CITY OF COCOA
Planning & Zoning Board /
Local Planning Agency
City Council Chambers

AGENDA
Regular Meeting
May 1, 2019
6:00 p.m.

A. A. PZ-18-00200017 – Large Scale Site Plan – Dr. Joe Lee Smith Community Center

Date:	April 29, 2019
Project Name:	Large Scale Site Plan - Dr. Joe Lee Smith Community Center
Project No.:	PZ-18-00200017
Meeting Date:	May 1, 2019
Planner:	Dodie Selig, AICP, Planning & Zoning Manager
Applicant:	City of Cocoa 65 Stone Street Cocoa, FL 32922
Property Owner:	City of Cocoa 65 Stone Street Cocoa, FL 32922
Project Location:	Two parcels of land at the southwest corner of Stone Street and Washington Street, addressed as 419 Washington Street and comprising the Dr. Joe Lee Smith Community Center complex. Brevard County Property Appraiser Parcel # 24-36-33-00-264 and 24-36-33-CC-12.E-2
Requested Action:	APPROVAL OF A LARGE-SCALE SITE PLAN consistent with Appendix A, Zoning, Article IV, Section 2, to construct a new 18,148 sq.ft. community center building, along with associated parking and stormwater retention, at the site commonly known as the Dr. Joe Lee Smith Community Center.

SHEET TITLE: SITE PLAN

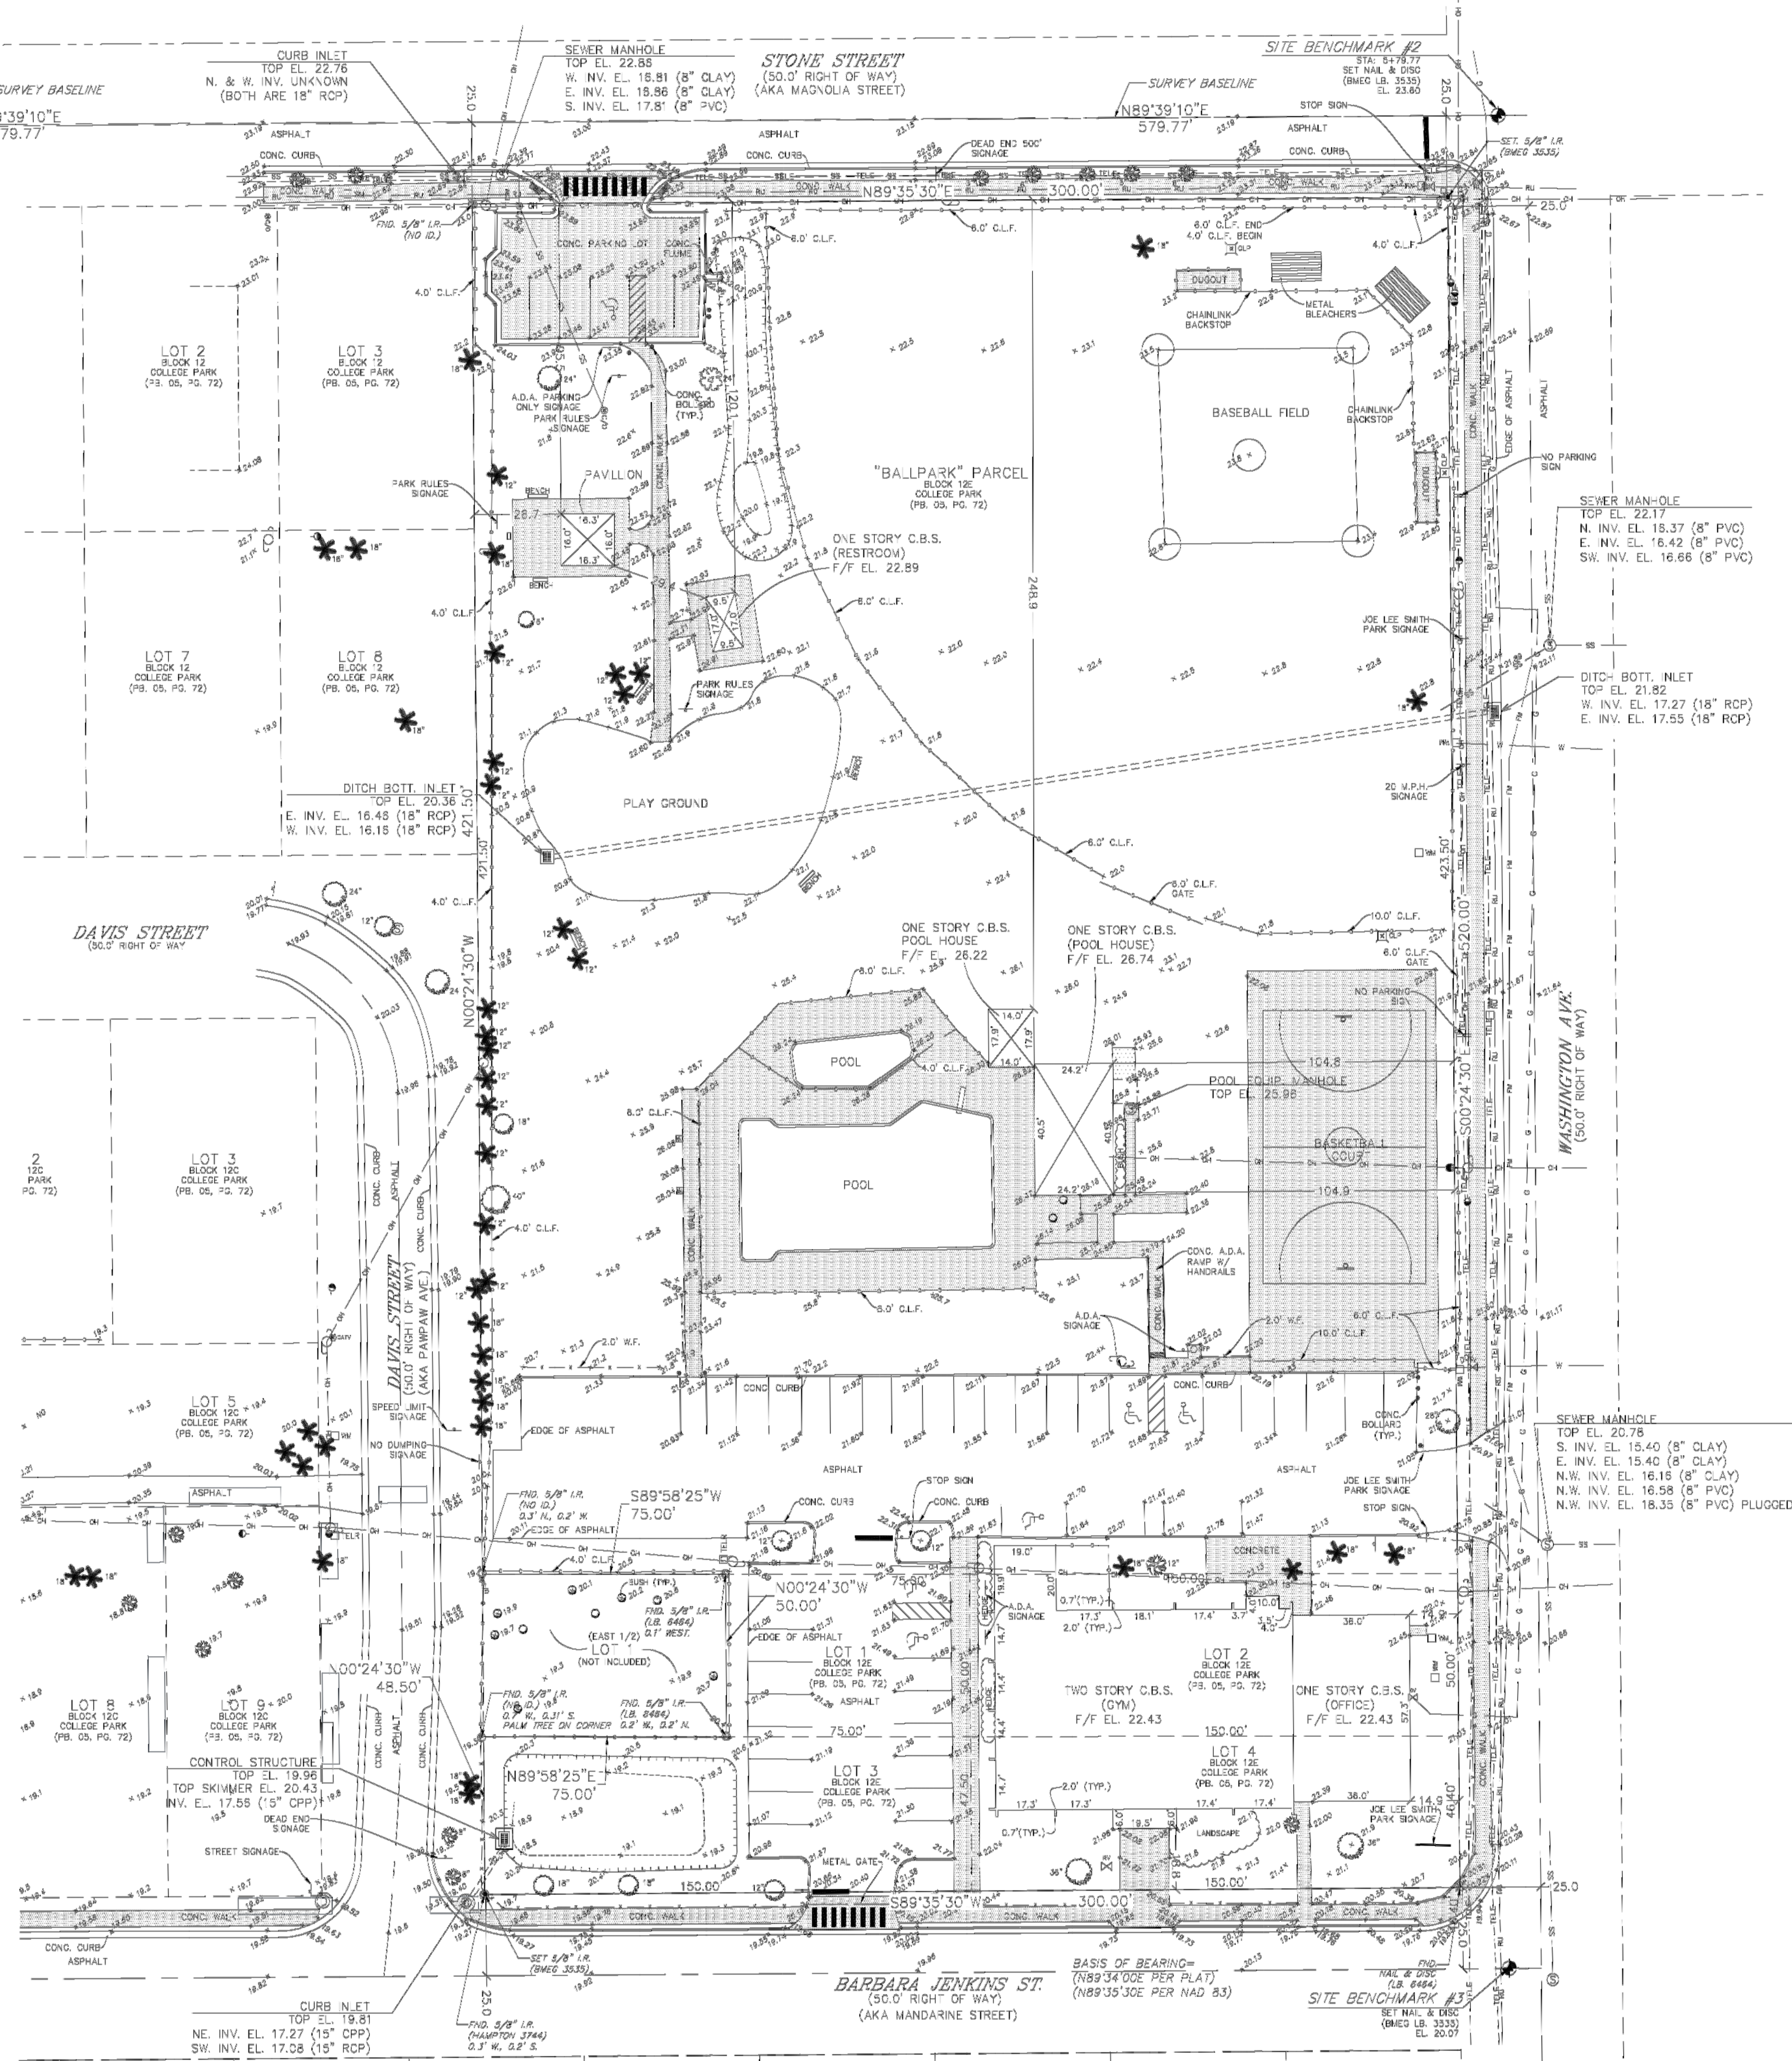
The original submittal of the site plan showed stormwater ponds with a 3:1 slope ratio. The Public Works department comment to the engineer was that this slope was too steep for safe mowing and too steep for the safety of children who might be in the area. The comment was addressed by the engineer with their resubmittal on April 16, 2019 by widening the size of the stormwater ponds and making the depth shallower. By moving the sides out and the bottom up the slope was reduced to a 5:1 ratio around the building and 4:1 for the one stormwater pond on the west side of the parking area.

As mentioned above, there is an issue with regard to parking spaces for this site plan. The site currently has a total of 47 parking spaces. The new site layout will remove 24 spaces but add back 49 for a net increase of 25 spaces. This will result in a new total of 75 parking spaces on the site.

It is therefore the recommendation of staff that the City Council approve a waiver of the required parking spaces from 143 spaces to the 75 spaces provided by this site plan as being both a more realistic reflection of the number of spaces needed as well as the greatest number of parking spaces possible on the site without eliminating other uses on the site. Construction of the new community center building with all of its planned amenities and facilities while preserving the existing building shall serve a great public interest and function which is not outweighed by the need for parking spaces.
